BP-14-1466-SFD  
63147 Riverstone Drive  
by: Dave Intel  
dt: 07/15/14

SUBMITTAL  
DRAWINGS  
STRUCTURAL AND  
ENERGY CODE  
REVISION

CONSTRUCT NEW 3685 SQ.FT. DWELLING

FIGURE R502.2.2.3  
DECK ATTACHMENT FOR LATERAL LOADS

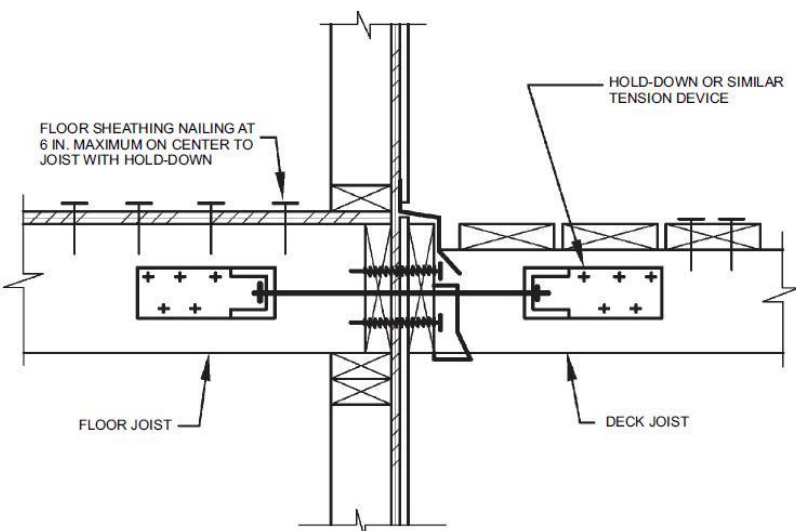
**Water Supply and Distribution Valves**  
605.2 A. fullway valve controlling outlets shall be installed on the discharge side of each water meter and on each unmetered water supply. Such shutoff valves shall be accessible at all times.

**APPROVED WITH  
ATTACHED  
ENGINEERING**

Effective January 1, 2013, AFCI protection requirements are as follows for subsection (A) Dwelling Units. All 120-volt, single phase, 15- and 20-ampere branch circuits supplying outlets installed in dwelling unit family rooms, dining rooms, living rooms, patios, porches, decks, bedrooms, sunrooms, recreation rooms, closets, attics, or similar rooms or areas shall be protected by a listed arc-fault circuit interrupter, combination-type, installed to provide protection of the branch circuit.

**R326:** Carbon Monoxide alarms shall be located in each bedroom or within 15 feet outside of each bedroom door. Bedrooms on separate floor levels in a structure consisting of two or more stories shall have separate carbon monoxide alarms serving each story.

**R312.3** Opening limitations. Required guards shall not have openings from the leading surface to the required guard height which allow passage of a sphere 4 inches (102 mm) in diameter.

**R311.3** Floors and landings at exterior doors. There shall be a landing or floor on each side of each exterior door. The width of each landing shall not be less than the door served. Every landing shall have a minimum dimension of 36 inches (914 mm) measured in the direction of travel. Exterior landings shall be permitted to have a slope not to exceed 1/4 unit vertical in 12 units horizontal (2 percent). The exterior landing or floor shall not be more than 8 inches (203 mm) below the top of the threshold provided the door does not swing over the landing or floor.
